PALISADES PLANT

STEAM GENERATOR REPAIR REPORT

Docket 50-255
License DPR-20

C-1 Provide the following additional information regarding ALARA considerations (Sections 1.1.5 and 4.3.5):

Figure C-3-1

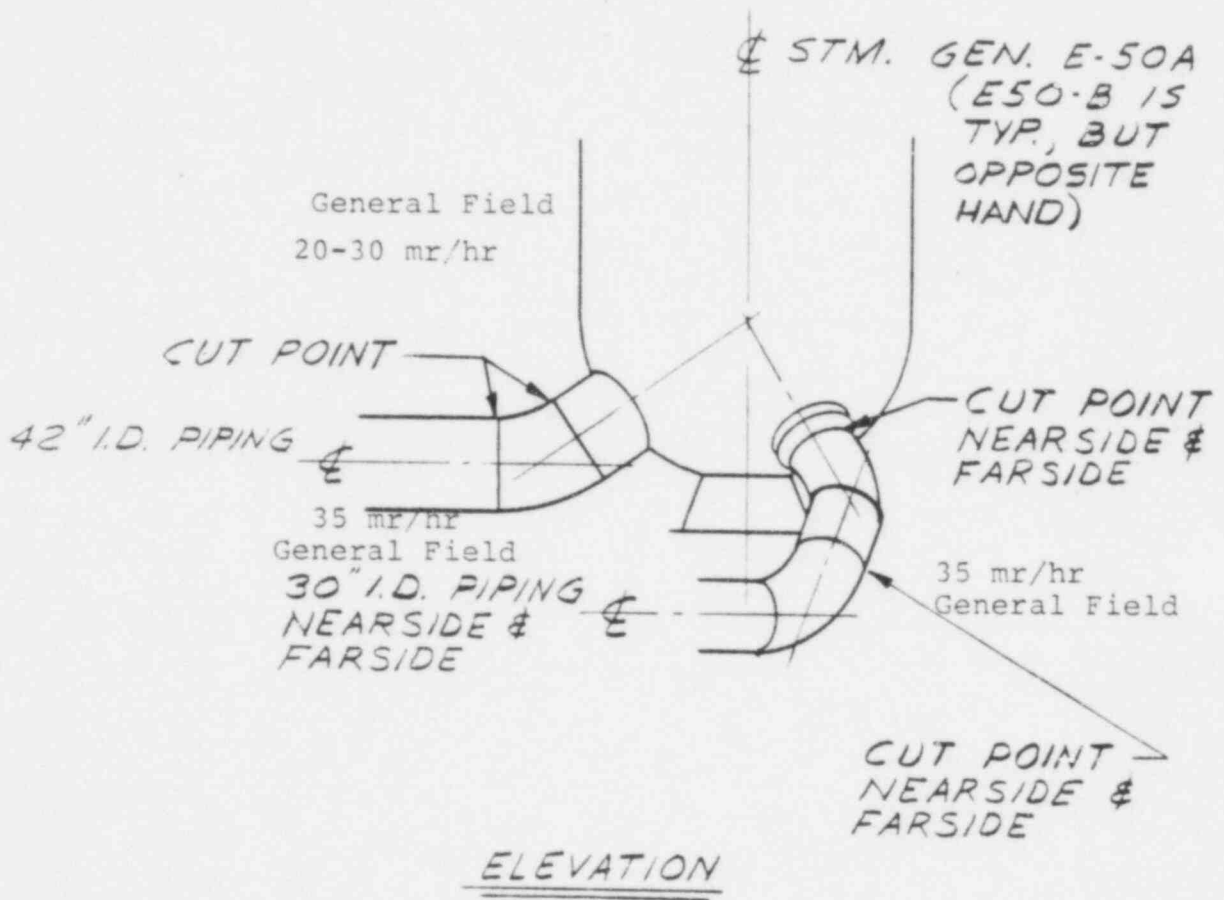
- C-3 Provide a diagram showing the radiation surveys around the steam generator replacement/repair activities. Include similar radiation surveys for Figures 4.2-4 through 4.2-7. Include a table showing the whole body dose received during the inspection and plugging of the degraded steam generator tubes for 1976, 1977, and 1978.

- Figures 4.3-3, 4.3-4, and 4.3-5, which are included in the Steam Generator Repair Report, show radiation surveys around the steam generators at various times after shutdown. The fields specified are representative of those expected for the replacement repair activities. It should be noted that the fields specified in Figure 4.3-5 are expected to decrease significantly at the time that pipe cutting begins, considered to be 42-140 days post-shutdown for study purposes. The decrease will follow the general radiation field near the steam generator piping shown in Figure 4.3-7. Figures 4.2-4 through 4.2-7 have been modified to include general field information in areas where replacement/repair activities will occur and are now designated as Figures C-3-1 through C-3-4.
